STATE OF NORTH CAROLINA  
DEPARTMENT OF TRANSPORTATION

April 21, 2005

Subject: **Individual Permit Modification Request for Action ID. 200430567, Project R-2813C, Widening of NC 146 (Long Shoals Road) between Interstate 26 and US Highway 25 (Hendersonville Road), south of Asheville, Buncombe County, North Carolina.**

PROJECT REFERENCE NO. R-2813C  
 R/W SHEET NO. HYDRAULICS  
 ROADWAY DESIGN ENGINEER  
 METRIX

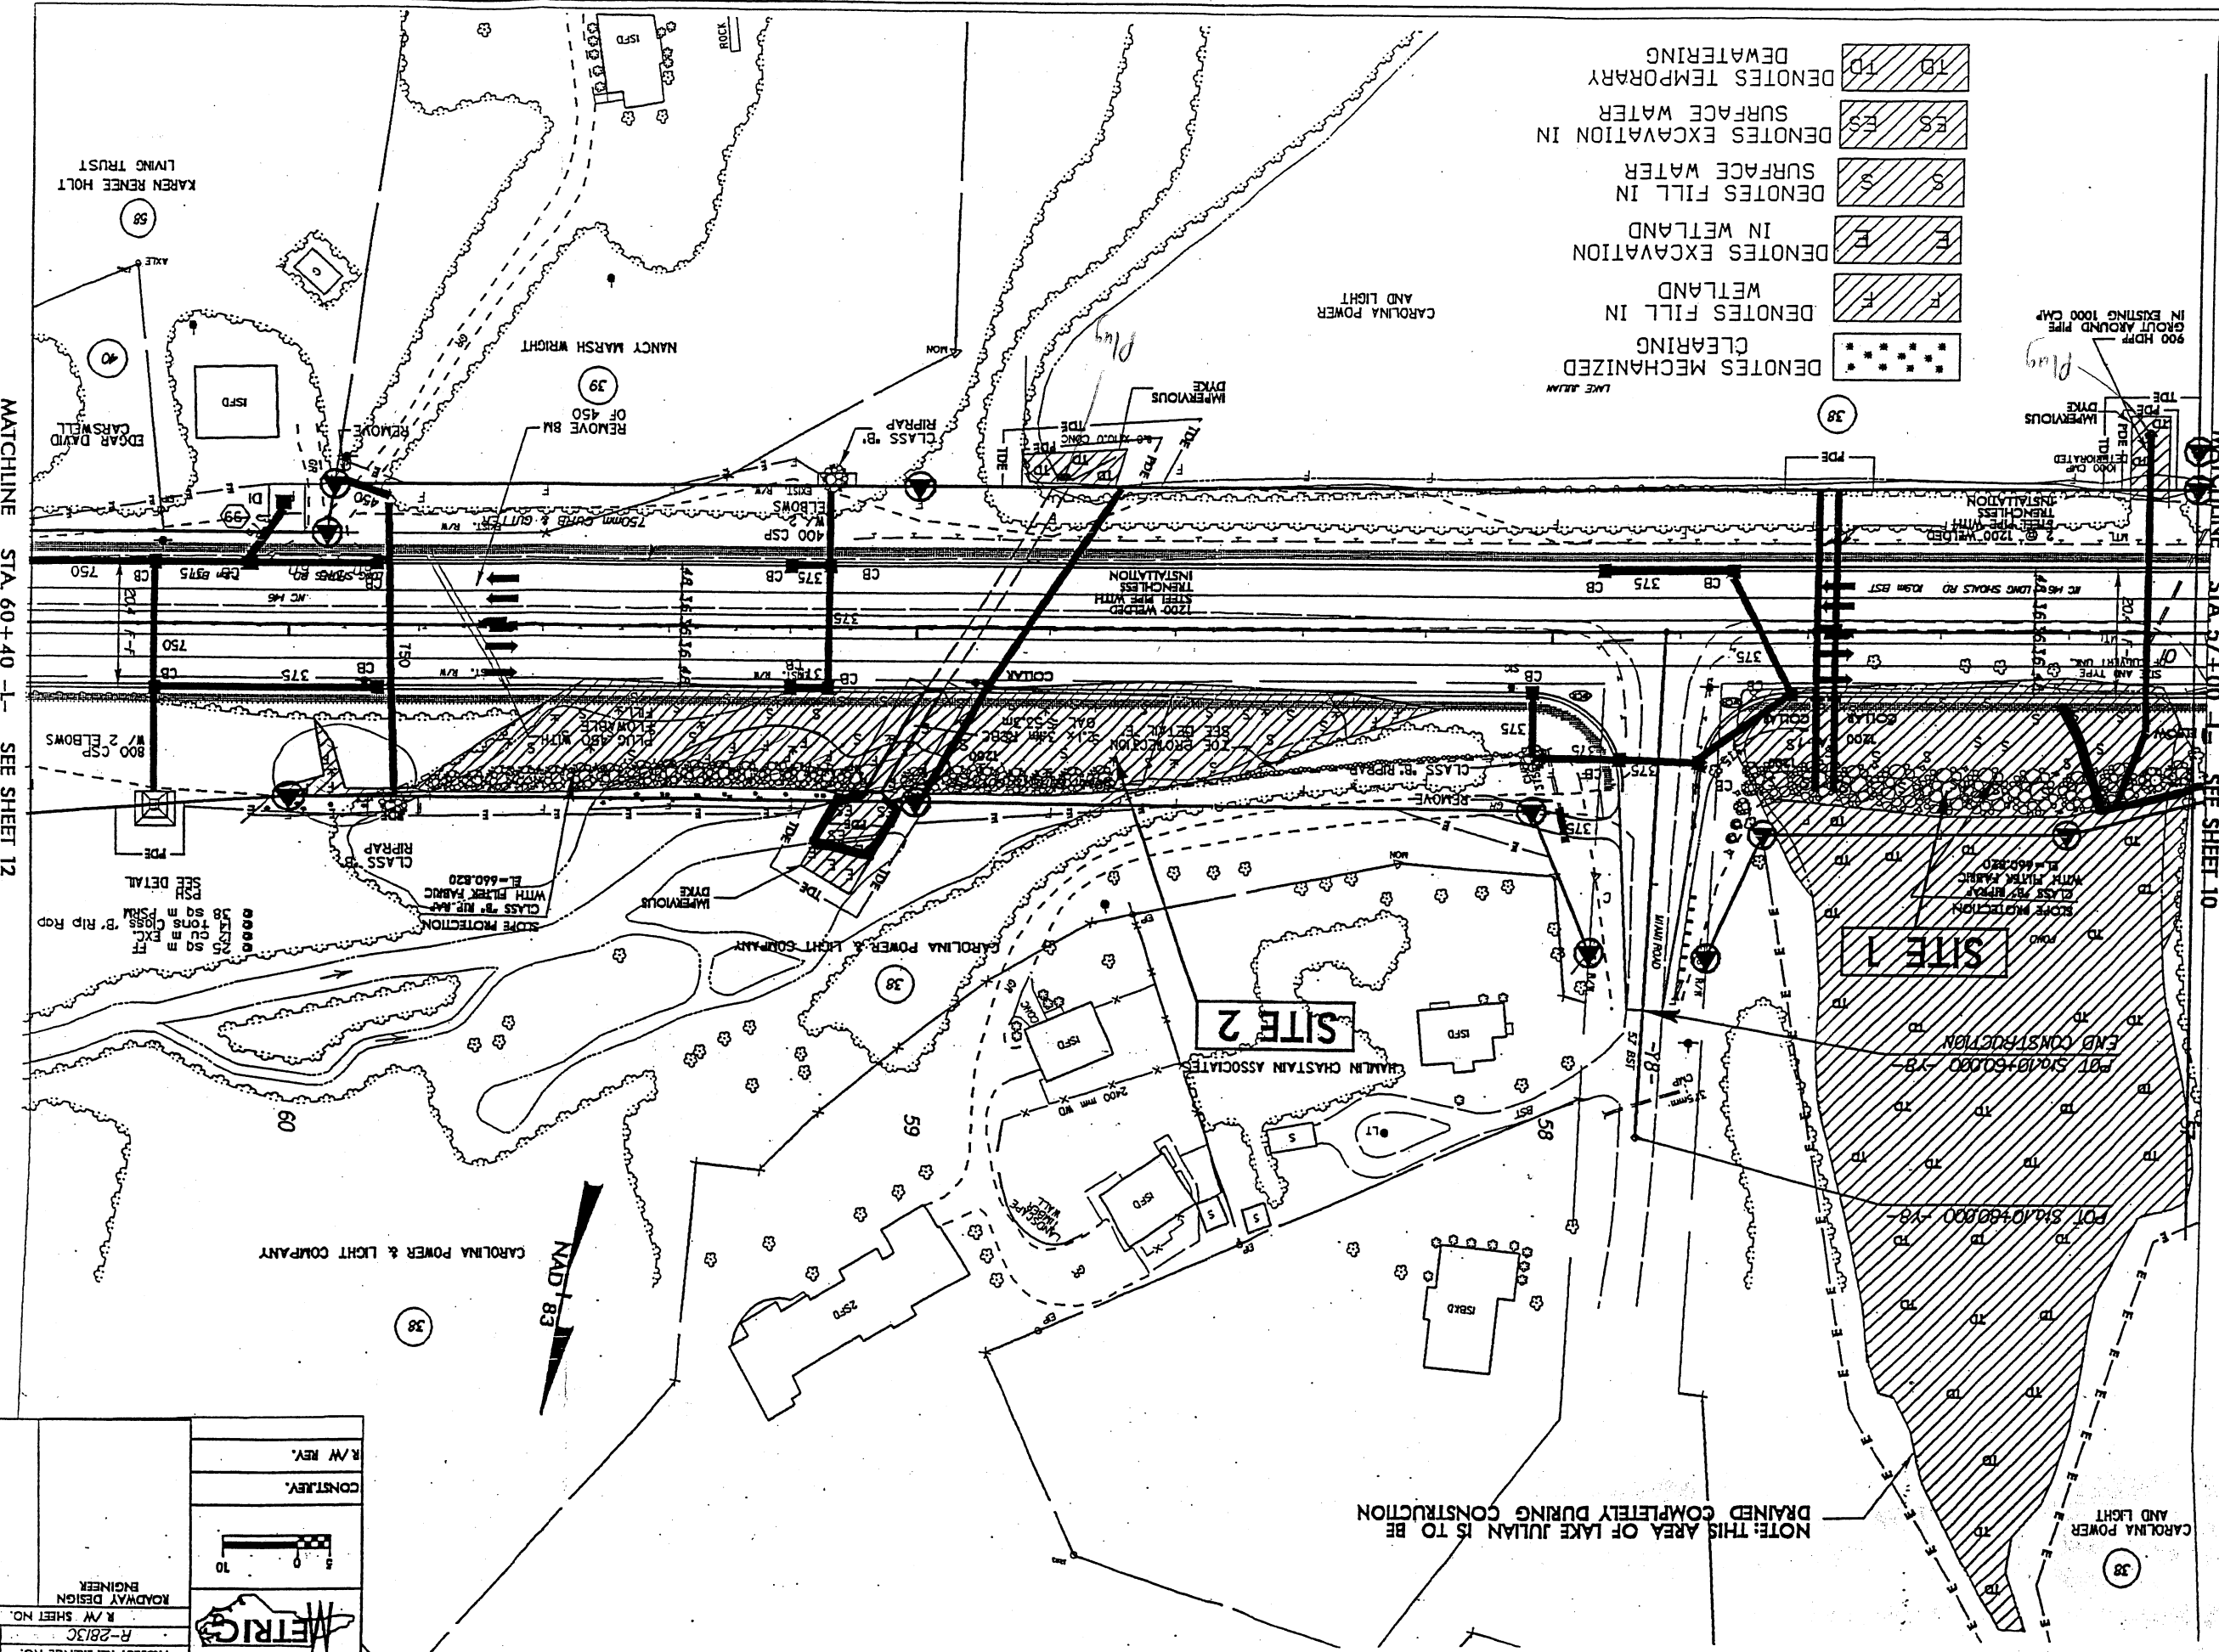
Rock fill will be placed on the east end of the finger of Lake Julian. Using this rock as a work pad, the bore and jack equipment can then be used to install the two 48-inch steel pipes. Once the two 48-inch pipes are in place, a plug will be used on the Lake Julian side to stop the flow of water through the damaged pipe rather than constructing an impervious dike. The rock will then be extended from the east side, isolating an area for equipment to repair the damaged pipe. Sheet piles may have to be used temporarily if the voids in the rock allow water to flow through. The water in this isolated area will be pumped through a silt bag and returned to the finger of Lake Julian. Any fish that are in this isolated area will also be relocated to the Finger of Lake Julian.

After reviewing installation methods for the previously permitted 8x10-foot culvert at Site 2, it has been determined that the temporary impervious dike on the Lake Julian side is not feasible. A plug will be used to stop the flow through the culvert during construction of the extension. Prior to the insertion of this plug, the previously permitted 48-inch steel pipe will be installed to accommodate flow.
